RIDE THE DUCKS INTERNATIONAL
Fleet Operations & Safety
2320 West Highway 76
Branson MO 65616

Bulletin No. SB-00-04-15
Release Date: 4/30/15
Effective Date: 4/30/15
Supersedes: N/A
Applicable to: Gas Powered Ducks
Total Pages: 4

SERVICE BULLETIN

EXAMPLE OF "SAFE T ALERT" VAPOR DETECTION INSTRUCTIONAL PLACARD

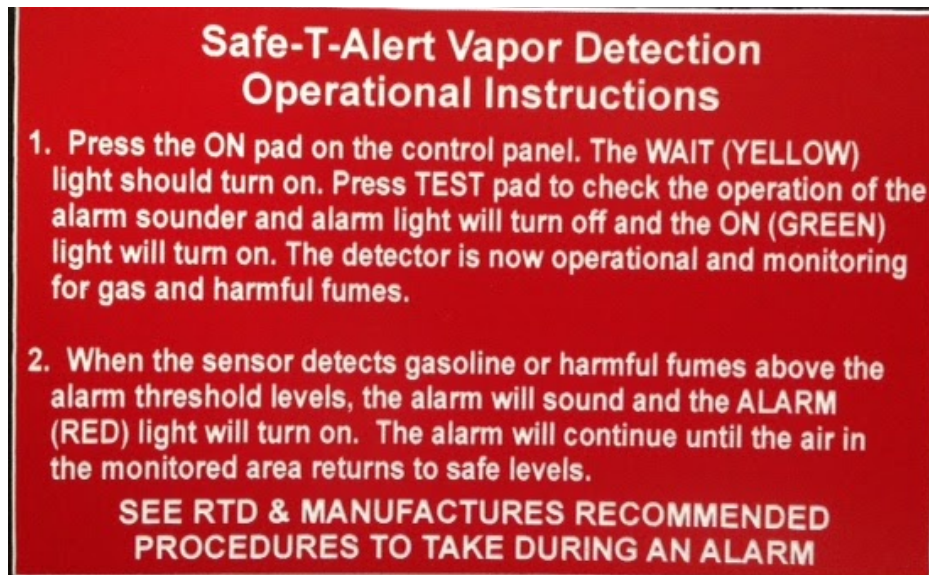
6. When replacing the Brisson units the instructional placard must be replaced as well. See Pg. 3 Example of "SAFE T ALERT" Instructional Placard.

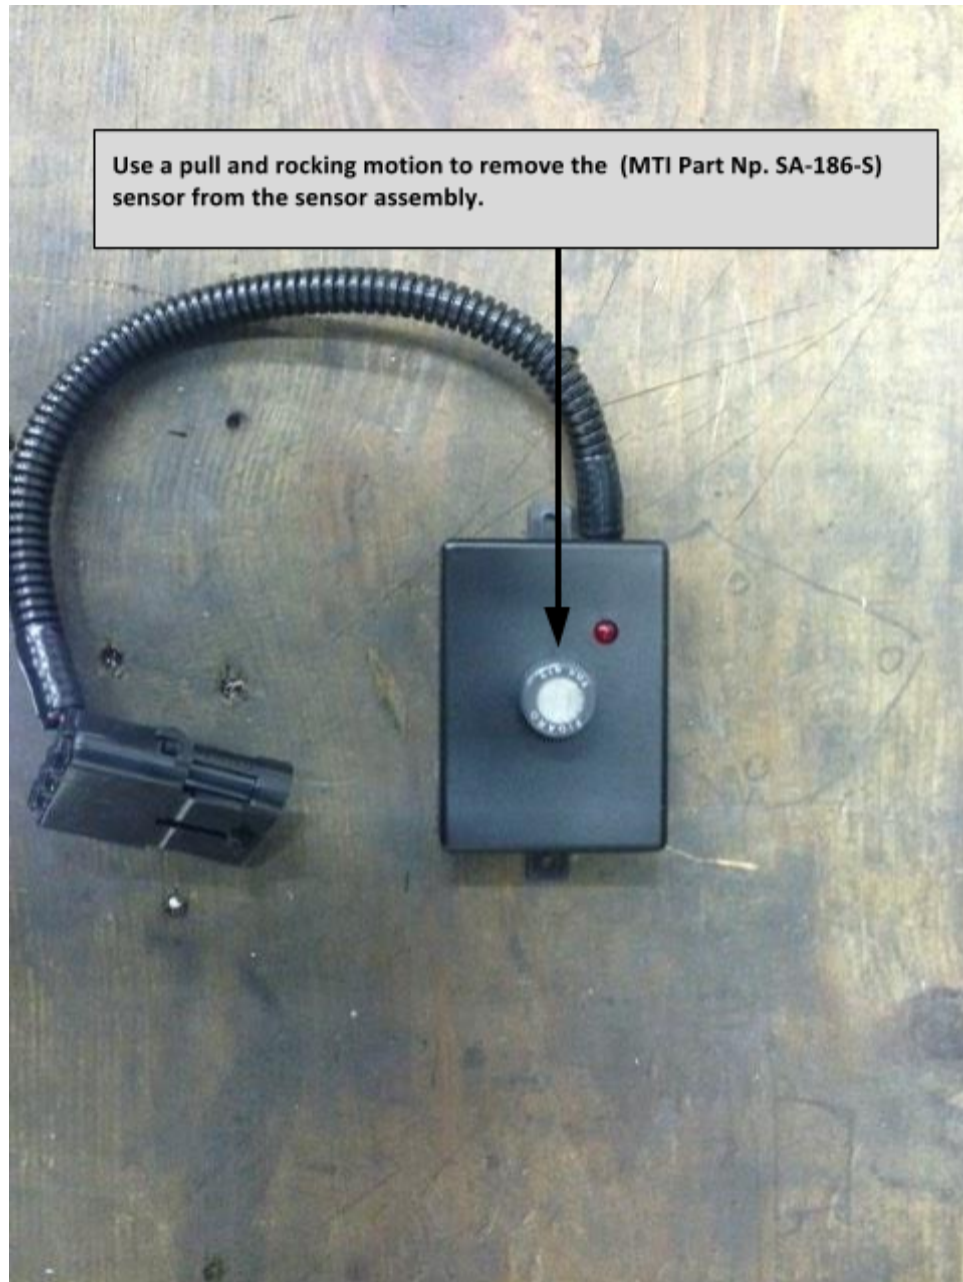
3. **SENSOR TEST:** Direct the lighter towards the sensor and depress the the lever to release gas into the sensor. The alarm should sound and the RED alarm light on the control panel should be lit.
4. **SUPERVISORY TEST 1:** Disconnect one end of the 20 foot connector cable. The alarm should sound and the RED alarm light on the control panel should be lit.
5. **SUPERVISORY TEST 2:** Use a pull and rocking motion to remove the sensor from the sensor assembly. See Photo PG 4. The alarm should sound and the RED alarm light on the control panel should be lit.
